TRANS/WP.29/2003/13
17 December 2002

**PROPOSAL FOR DRAFT SUPPLEMENT 8 TO THE 03 SERIES
OF AMENDMENTS TO REGULATION No. 36**

(Large capacity passenger vehicles)

"Figure 10

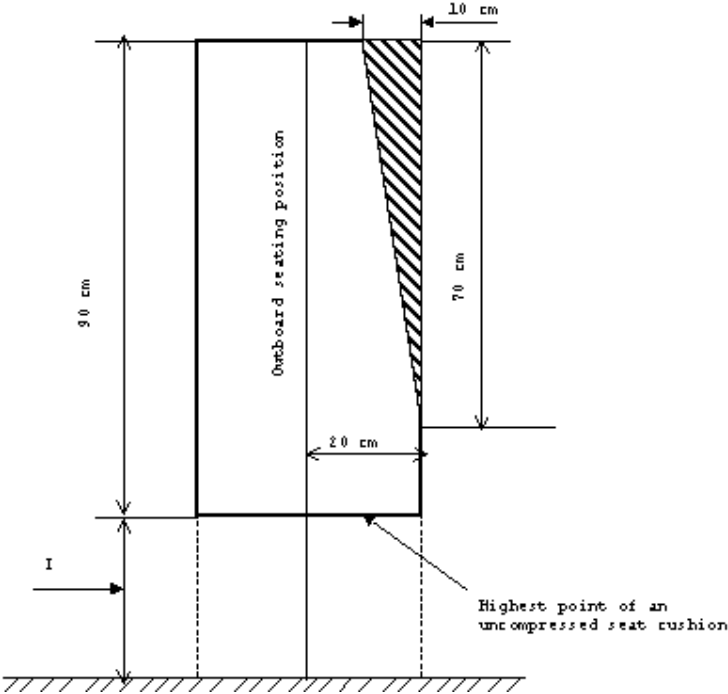
Paragraph 5.7.8.6.2.2., amend to read:

"5.7.8.6.2.2. Intrusion of a structural member provided that the intrusion is included within a triangle whose peak is situated 70 cm from the top and whose base is 10 cm in width and situated in the upper part of the space in question, adjacent to the side wall of the vehicle (see annex 3, figure 10);"

Annex 3, Figure 10, amend to read:

PERMITTED INTRUSION OF A STRUCTURAL MEMBER

I (cm) min.
Class I	40-50
Class II	(for classes I and II min 35 cm at wheel arches and engine compartment)
Class III
